SUBJECT: COMANCHE PEAK NUCLEAR POWER PLANT, UNITS 3 AND 4
DOCKET NUMBERS 52-034 AND 52-035
RESPONSE TO REQUEST FOR ADDITIONAL INFORMATION NO. 3183

Attachment 1. Response to Request for Additional Information No. 3183 (CP RAI #88)

SRP SECTION: 13.03 - Emergency Planning

RAI 13.03-22

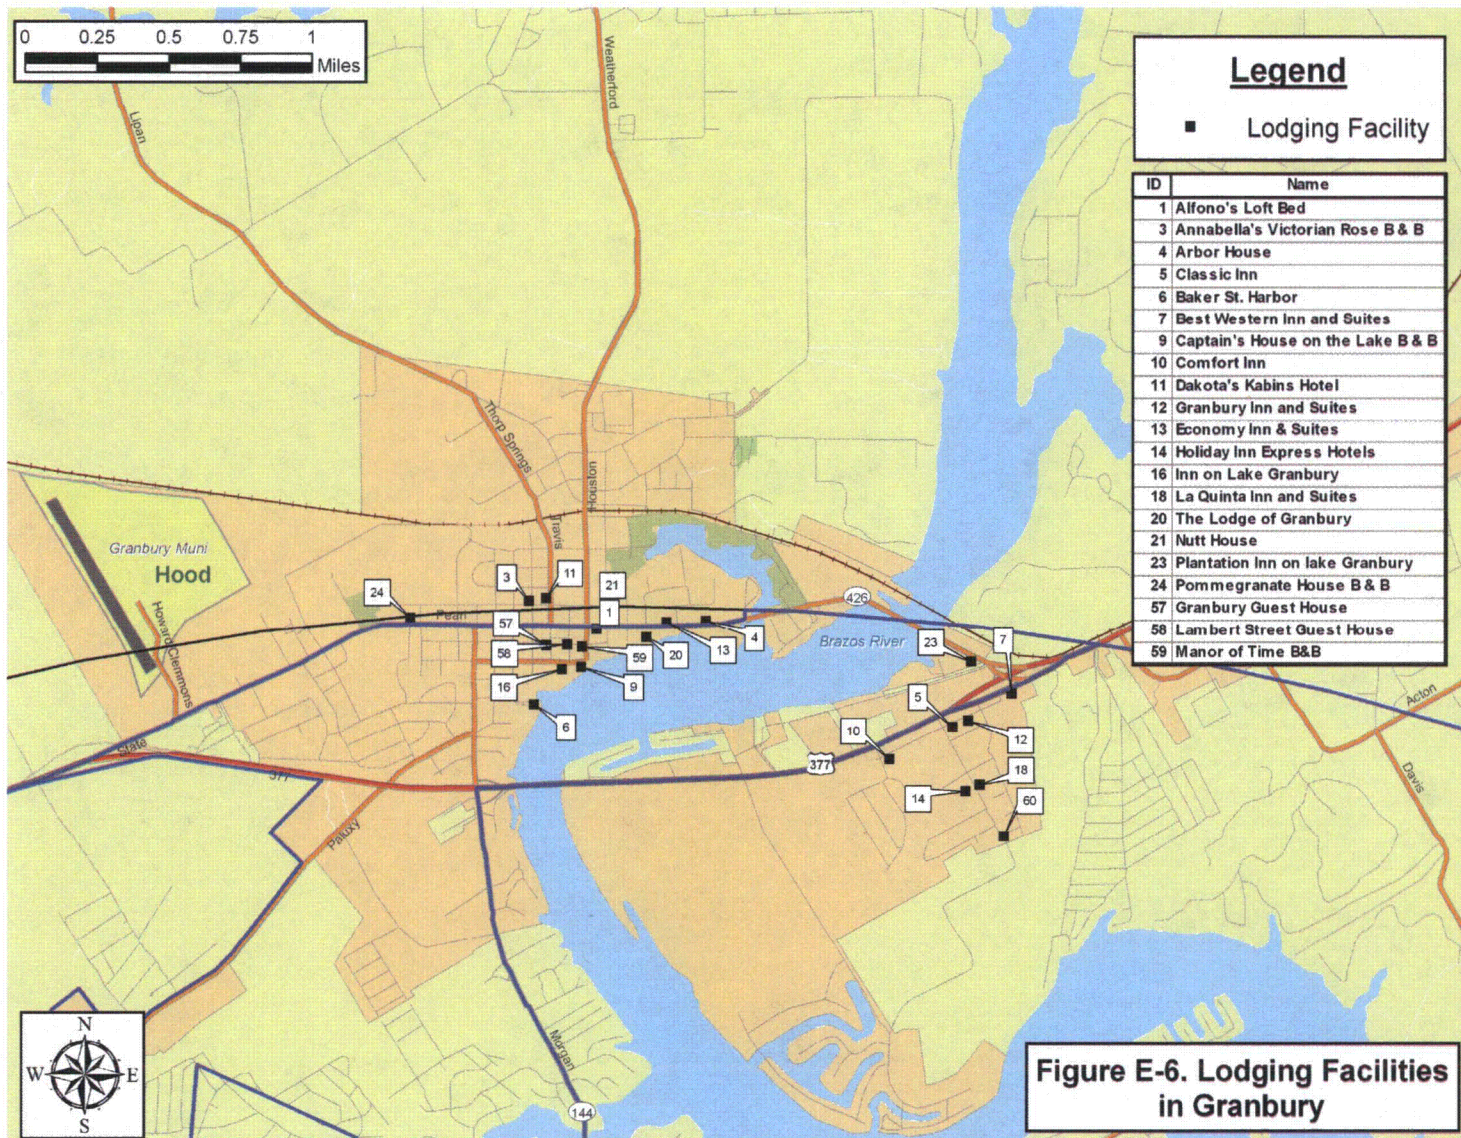
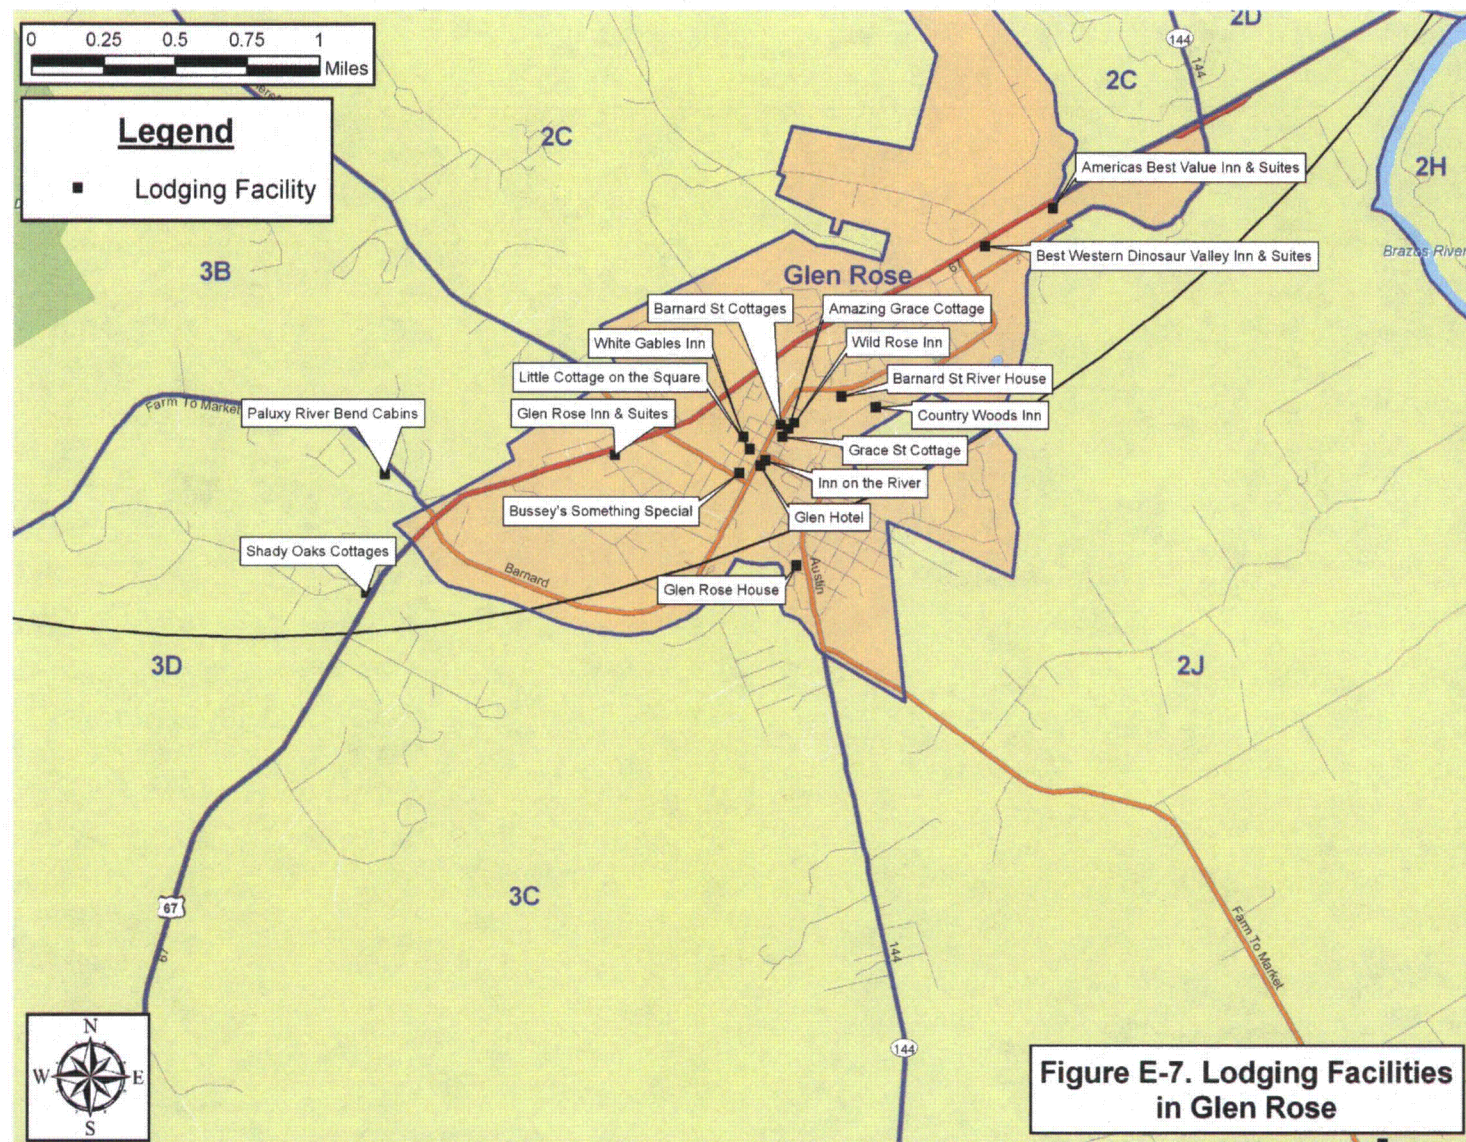
- Added new Figure E-1 which maps the schools and day care facilities in the EPZ.
 - Added new Figure E-2 which maps the medical and correctional facilities in the EPZ.

- Former Figure E-1, which identifies the major employers in the EPZ was re-numbered as Figure E-3. Also, labels identifying each of the major employers was added.

- Former Figure E-2, which identifies the recreational areas in the EPZ was re-numbered as Figure E-4.
 - Former Figure E-3, which identifies the lodging facilities in the EPZ was re-numbered as Figure E-5. Also, labels identifying each of the lodging facilities were added. Due to the high density of lodging facilities in Granbury and Glen Rose, insets were drawn around these areas in Figure E-5. Maps of these inset areas are added as Figures E-6 and E-7 for Granbury and Glen Rose, respectively.
